PLAN FOR PROPOSED IMPROVEMENTS

CONGESTION MANAGEMENT PROGRAM

DETECTION UPGRADE SET #2

DIVISION OF PUBLIC WORKS
CONGESTION MANAGEMENT PROGRAM
DETECTION UPGRADE SET #2
SHELBY COUNTY, TN.

U.S. HWY. 64 AT BROTHER BLVD.
INTERSECTION LAYOUT

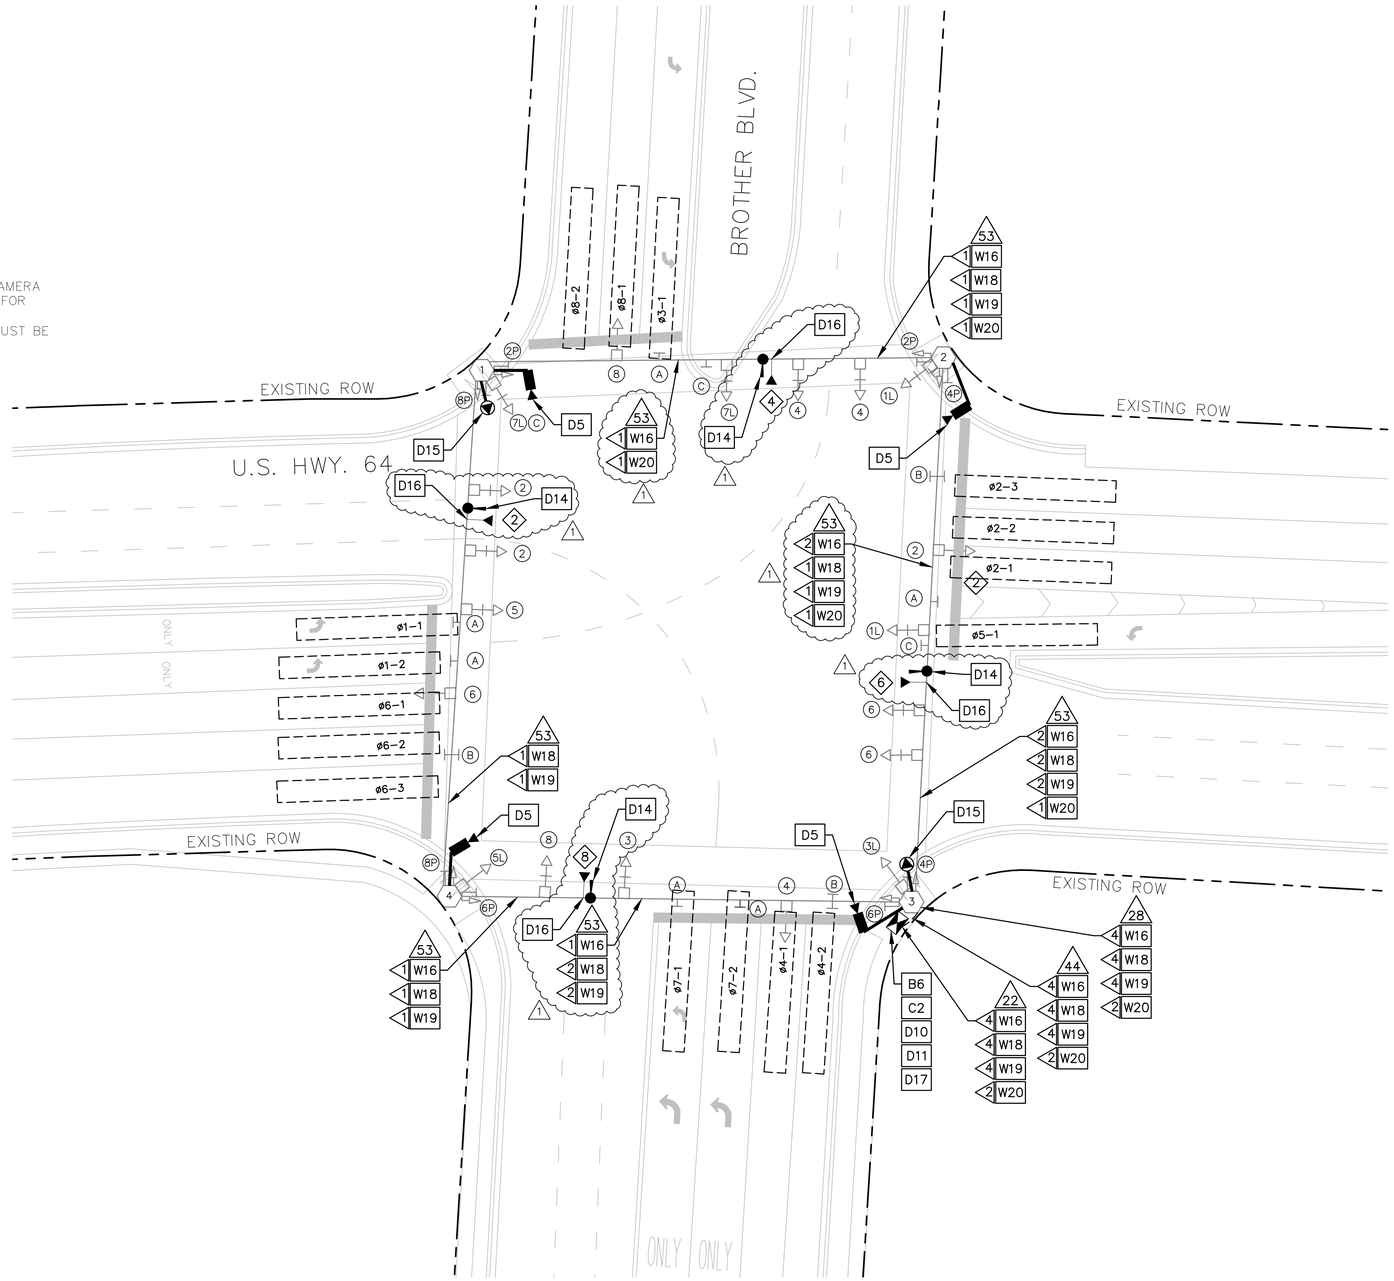
DATE	DESCRIPTIONS	APPROVED
10/2013	MOVED EVP DETECTORS	
	AND REMOVED PROP.	
	STRIPING

.S. HWY. 64 AT BROTHER BLVD.
DETAILS

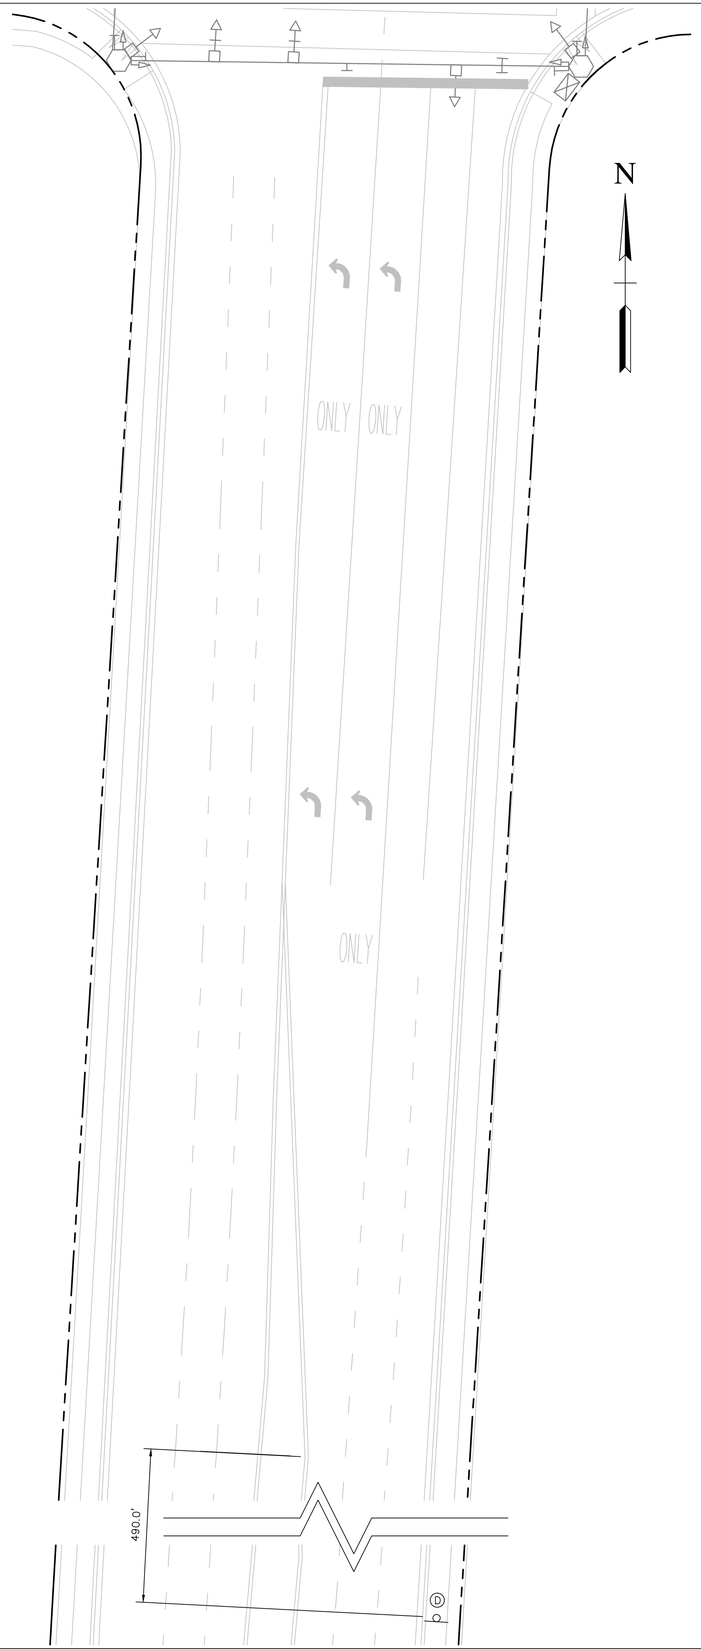
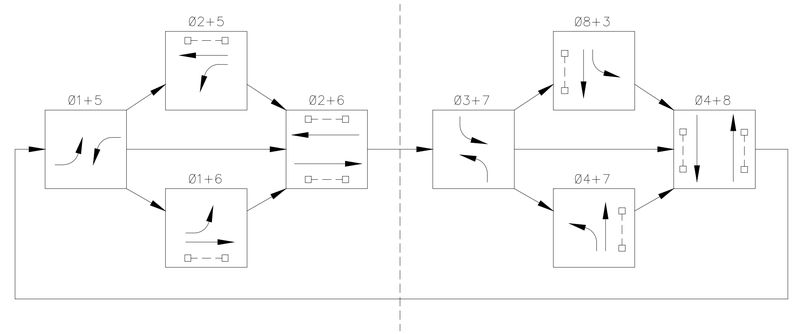
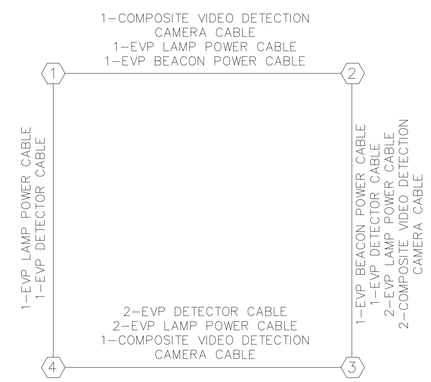
REVISIONS			
	DATE	DESCRIPTIONS	APPROVED
1	10/2013	REMOVED PROPOSED STRIPING

ELMORE RD. AT BARTLETT BLVD.
INTERSECTION LAYOUT

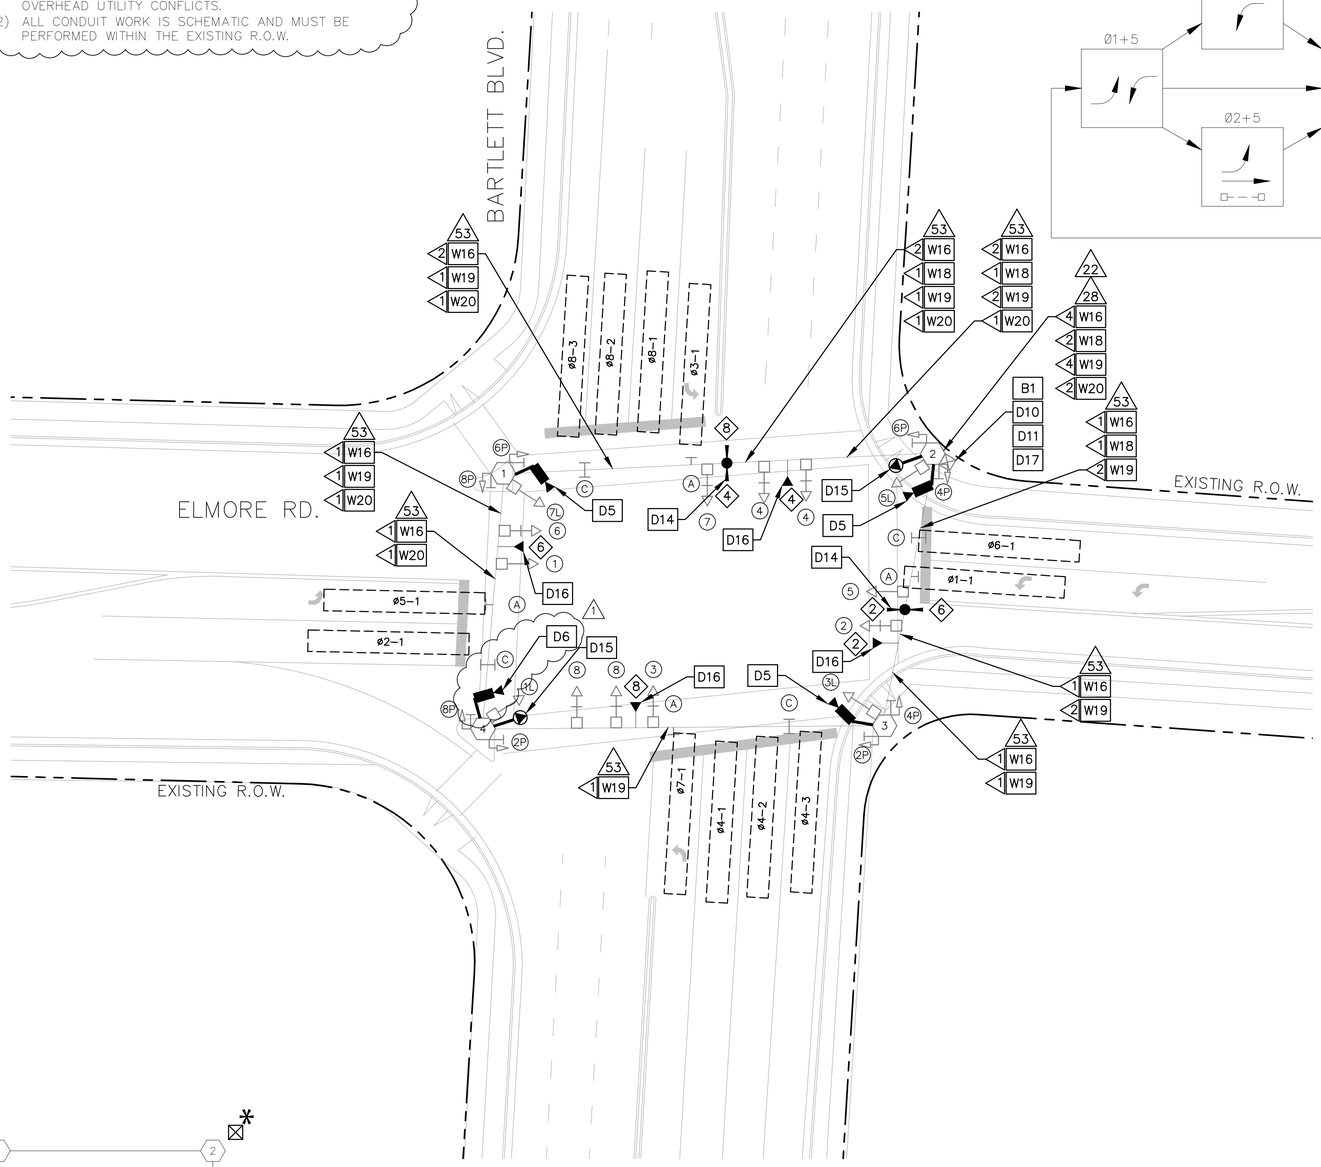
REVISIONS		
DATE	DESCRIPTIONS	APPROVED
10/2013	CHANGED CAMERA MOUNTING TYPE

U.S. HWY. 70 AT MEMPHIS–ARLINGTON RD. INTERSECTION LAYOUT

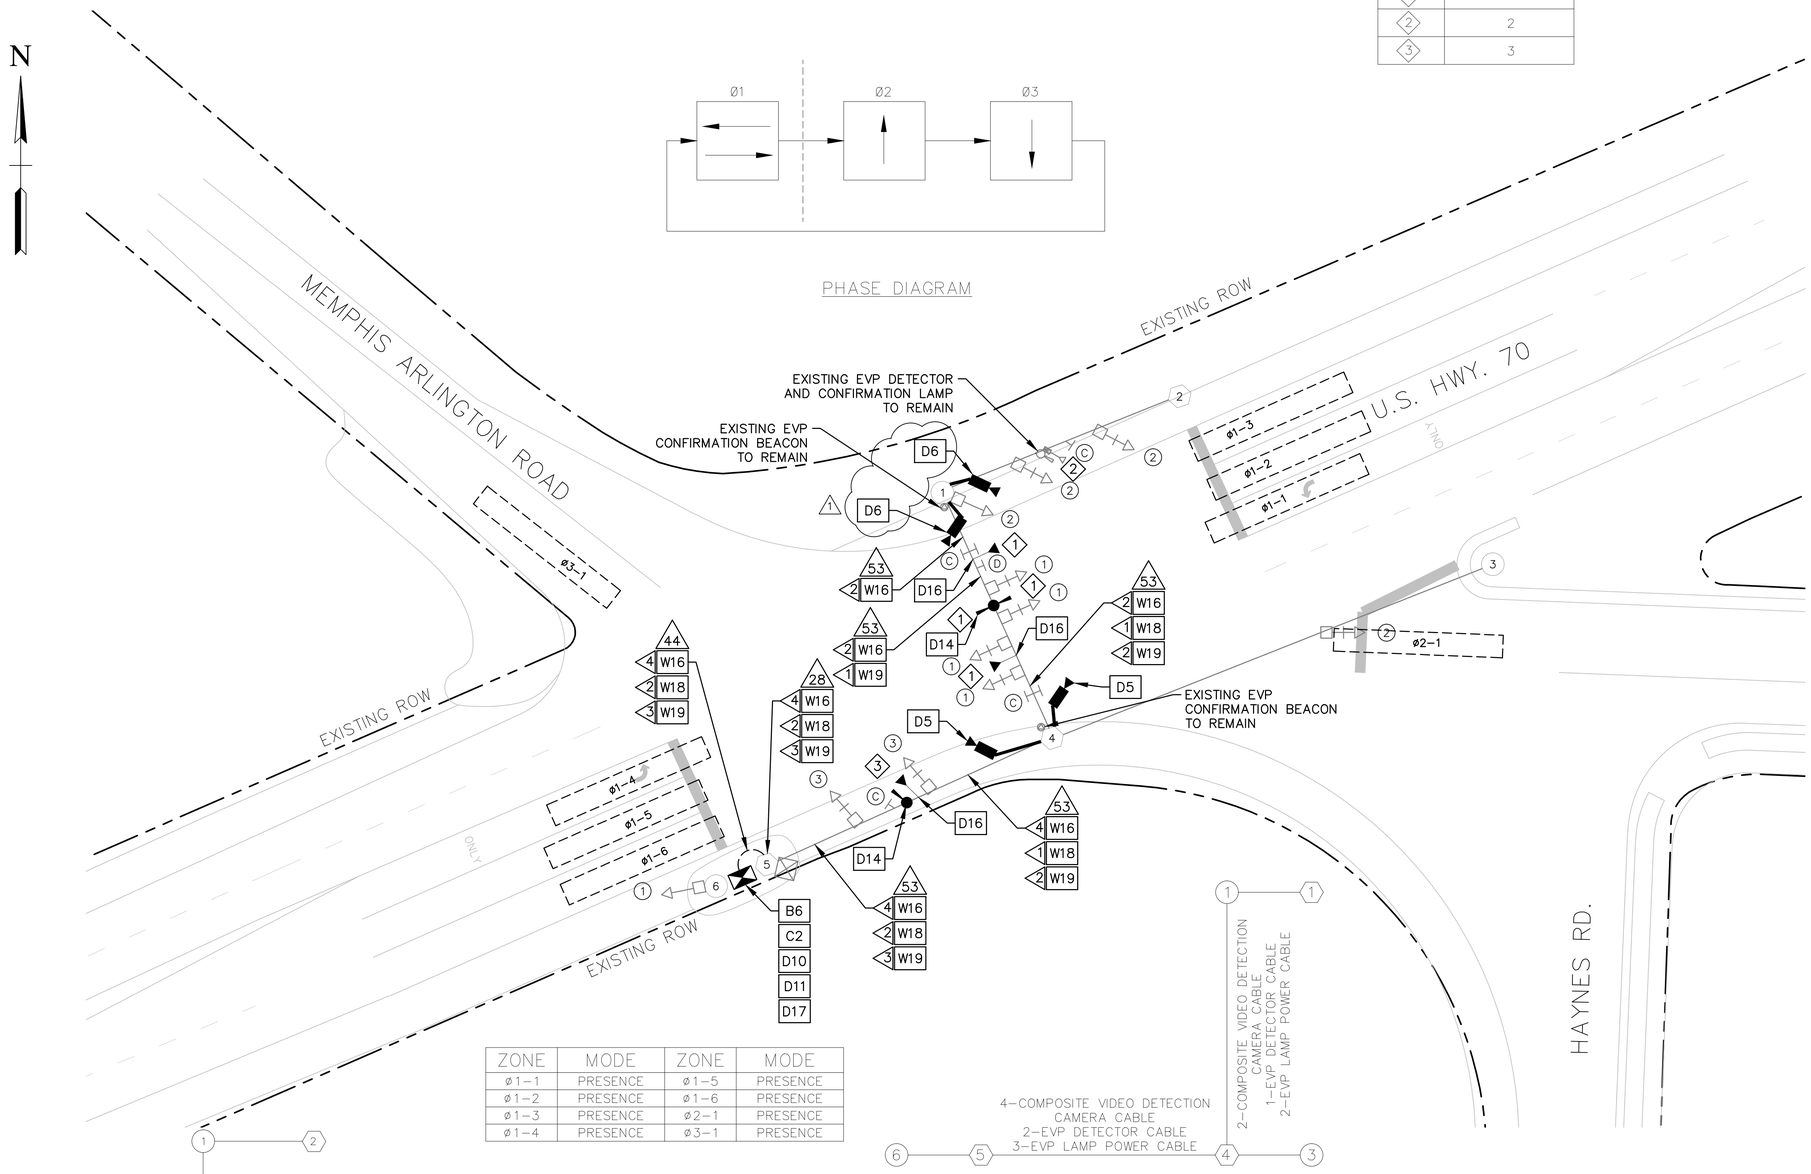
REVISIONS		
DATE	DESCRIPTIONS	APPROVED
1 10/2013	CHANGED CAMERA MOUNTING TYPE

WOLF RIVER BLVD. AT RIVERDALE RD.
INTERSECTION LAYOUT

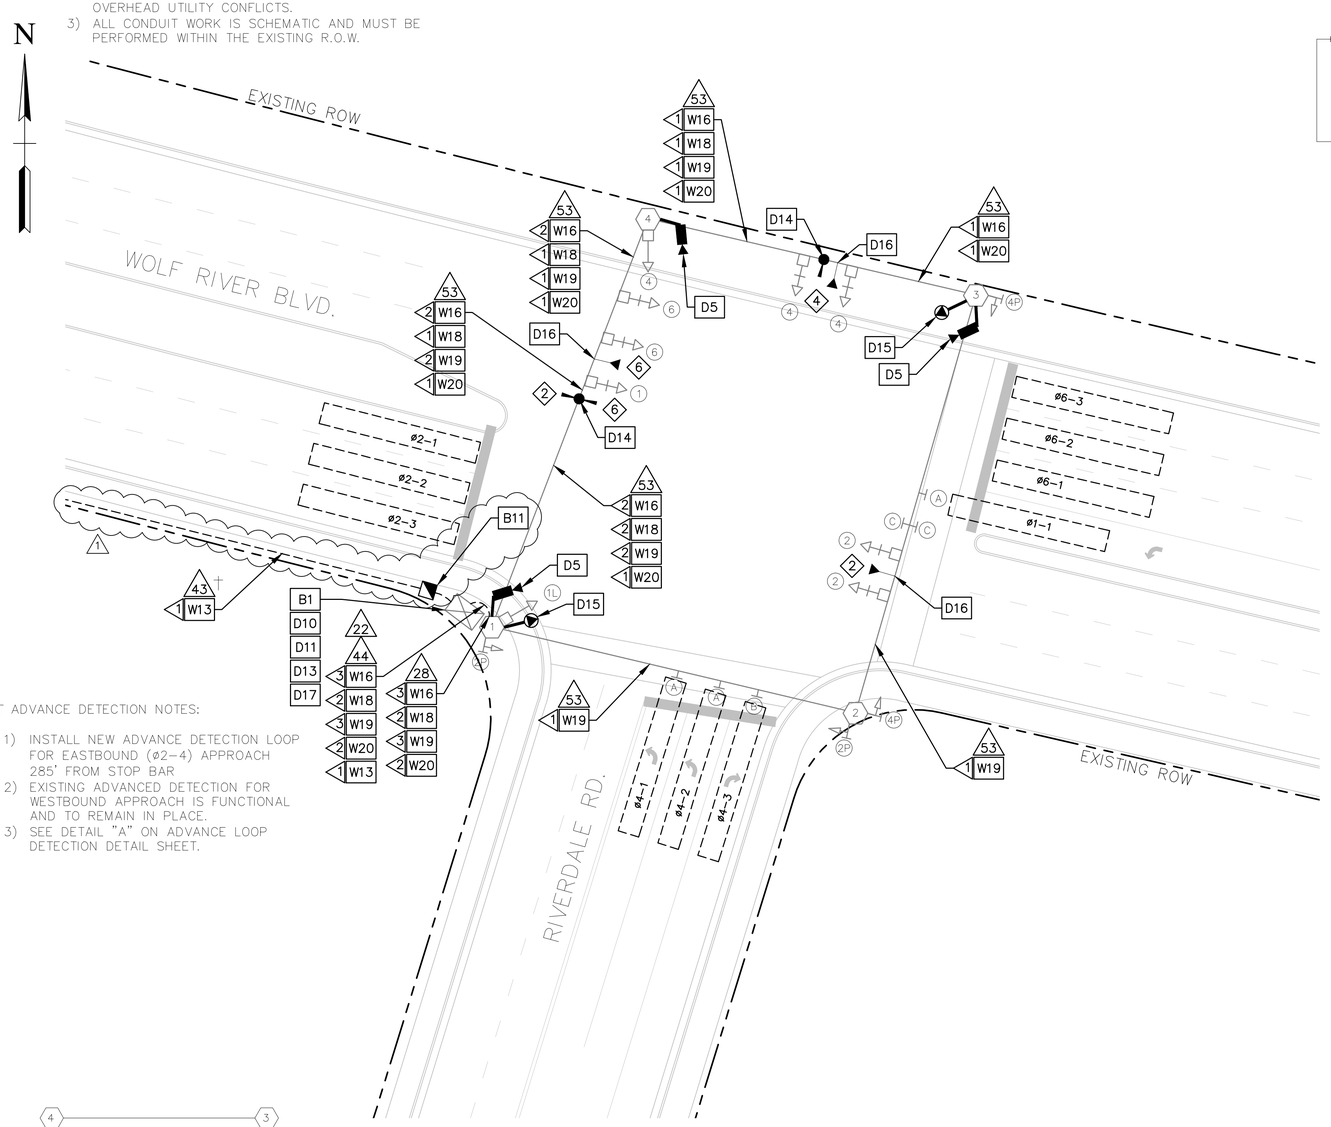
DATE	DESCRIPTIONS	APPROVED
1	10/2013	MOVED EB ADVANCE	
		DETECTION CONDUIT

NAVY RD. AT BETHUEL RD.
INTERSECTION LAYOUT

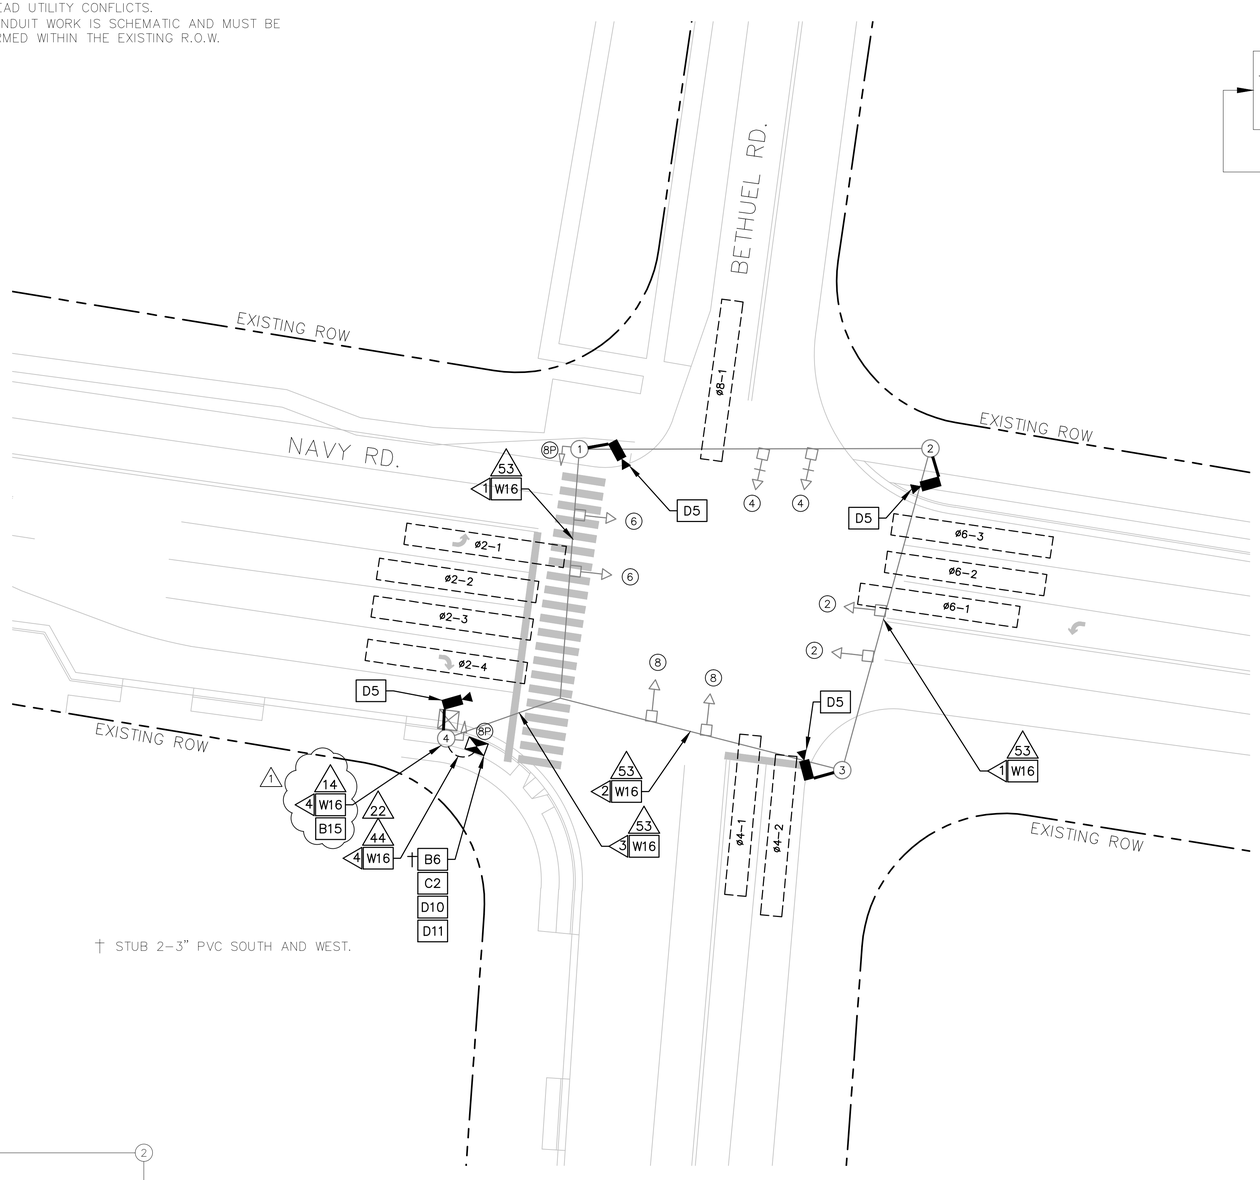
DATE	DESCRIPTIONS	APPROVED
1	10/2013	ADDED JUNCTION BOX
